Response to Leicestershire County Highways Comments of 13 March 2025:

Internal Layout Compliance Report

Prepared by: The Greenfield Design Partnership Ltd

Annotated layout plan highlighting drives to Plots 106, 107, 108, 109, 117, and 118 with direct frontage access to STR 13.

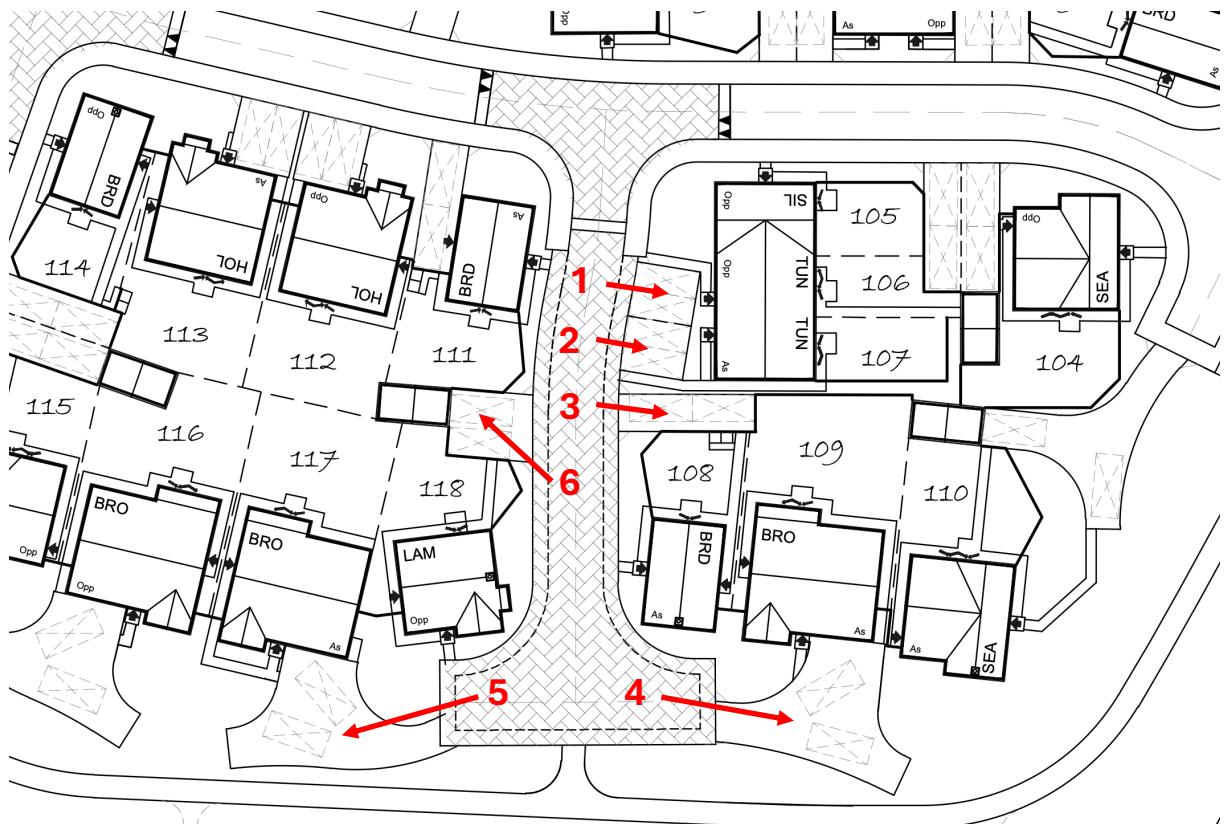
The LHA has raised concerns that the roads (STR 13 and STR 14) do not serve the minimum of 6 direct frontage access points as required by the LHDG. We confirm that both roads meet this requirement, as detailed below.

Contrary to the LHA's observation, STR 13 serves 6 plots with direct frontage access. The plots are:

1. Plot 106
2. Plot 107
3. Plot 108
4. Plot 109
5. Plot 117
6. Plot 118

All listed plots have direct frontage access to STR 13, with no reliance on private drives for these connections.

Annotated layout plan highlighting Plots 75, 76, 77, 78, 80, and 81 with direct frontage access to STR 14.

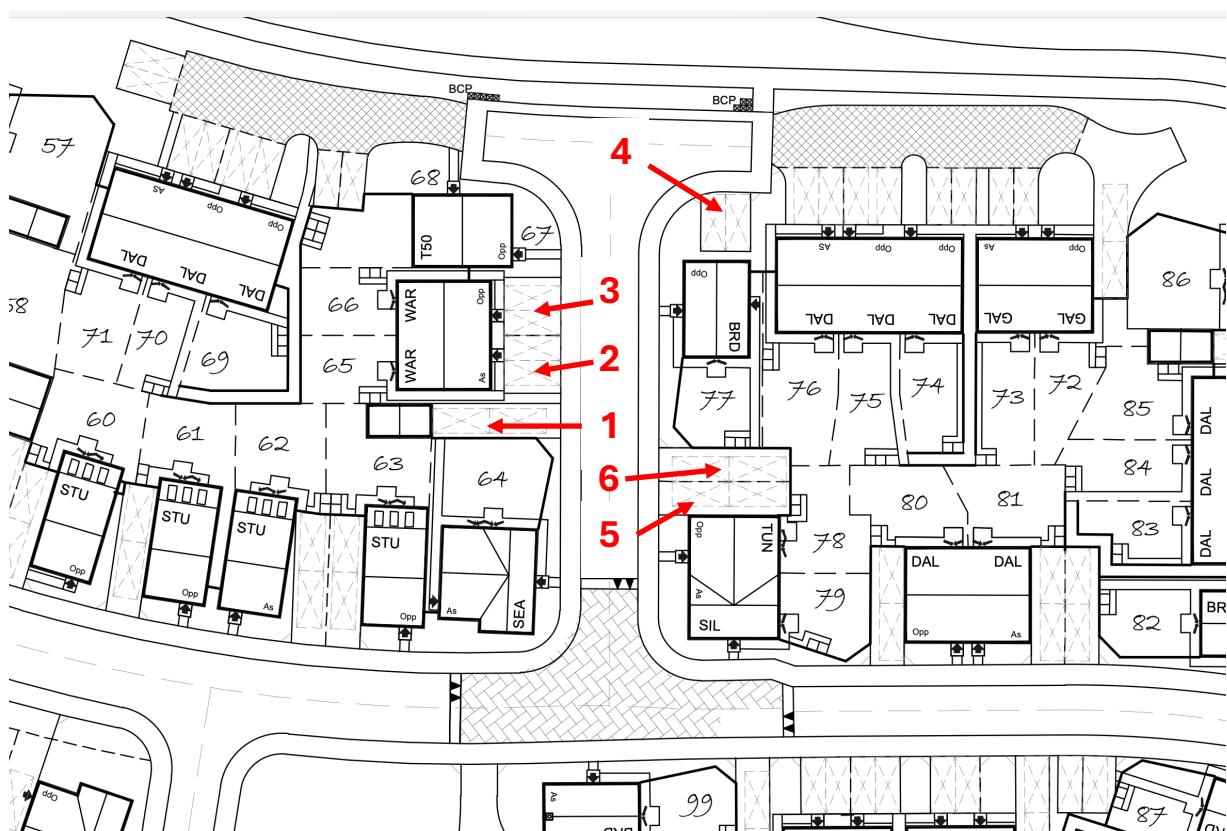
Similarly, STR 14 serves 6 plots with direct frontage access:

1. Plot 64
2. Plot 65
3. Plot 66
4. Plot 77
5. Plot 78
6. Plot 79

Plot 79 does not have direct frontage access to STR 14, as it is served via a private drive. However, the six plots listed above all have direct frontage access to STR 14, satisfying the LHDG requirement.

The LHA notes that STR 14 may be intended for future development extension and advises that it will not be adopted due to insufficient direct frontage access points. As demonstrated above, STR 14 serves 6 plots with direct frontage access, meeting LHDG standards. We assert that STR 14 is eligible for adoption, and any future extension will be designed to comply with LHDG requirements at that stage.

Extract of the design plan showing the bend with forward visibility sightlines annotated.

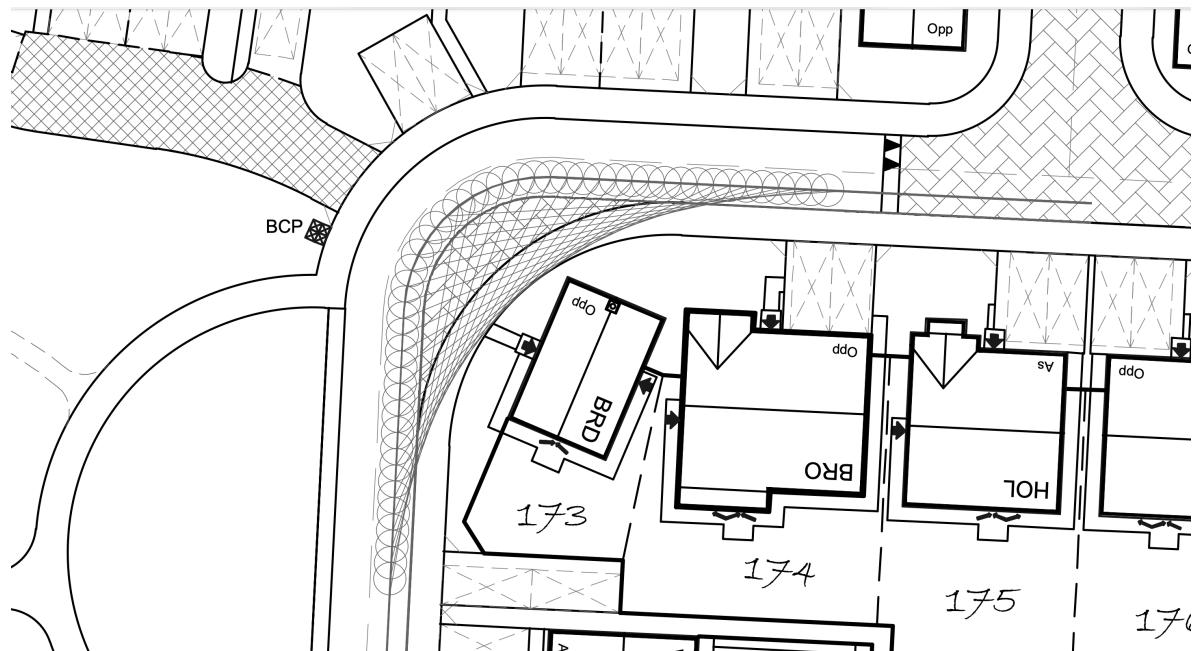
3. Forward Visibility at Bend

The LHA requests details of forward visibility at the specified bend. The design ensures compliance with LHDG standards, achieving a forward visibility distance of 25 meters at the bend in question. This meets the minimum requirements outlined in Table DG3 of the LHDG.
